APPROVED MINUTES OF THE MEETING

August 6, 2009

Westlake Transportation Hub Strategy

Linden Ave N Improvements

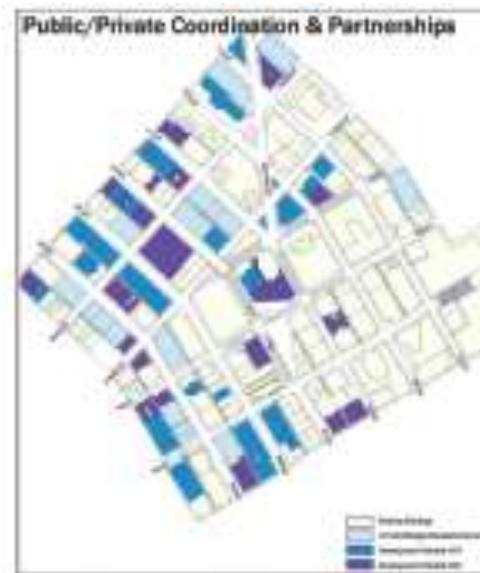
It seems like a very rich and complicated project you are dealing with. You mentioned the way-finding along 5th Ave., is there a formal list that you have in order of importance?

When I look at it the 5th Ave. connector seems like such a key part of the plan. There is no connection existing today that is clear and strong.

The idea of an iconic symbol that connects these areas is really important and goes beyond the power of signs and maps. It could be a color or type of paving.

The retail sales are significantly less along 5th Ave. as a result of the columns of the monorail providing a visual barrier.

If you are to redevelop these two parks projects, in thinking about the materials that might be used and the Westlake plaza design might influence these to tie them together. Stepping back and having some key goals and a diagram that shows all the areas together would be helpful since this is such a complicated plan. The colors are fighting against each other so more variety might help and the font size could be reduced in some cases. Images of the area would also be helpful to orient people to the area.

We have not filled out a list for a 10-year strategy, which will be done. Early on we focused on private development and trying to leverage that, which is not feasible now with the collapse of the economy.
